**Notice of Allowability**

09/380,351

EDDY ET AL.

FIG. 1

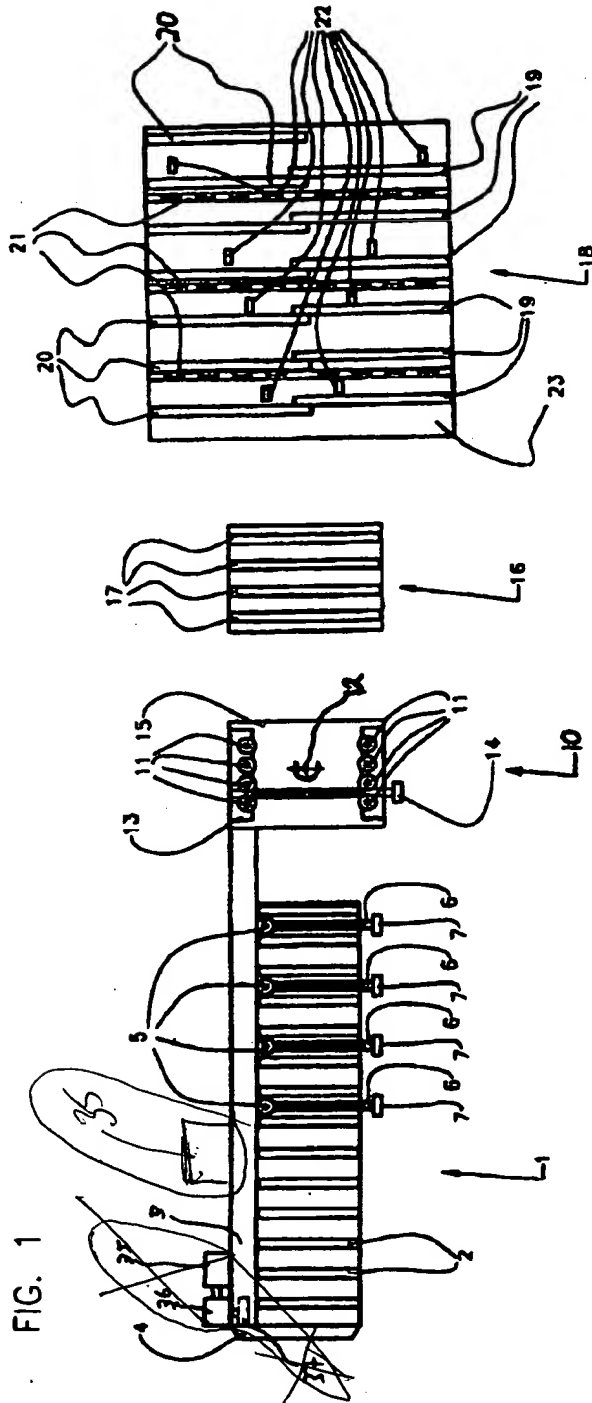
In Figures 1 and 3, the added structure including numerals 35, 36, 37 and the specific structure related thereto will be removed and a box indicated by numeral 35 will be added as shown in the approved marked-up drawings included herewith.
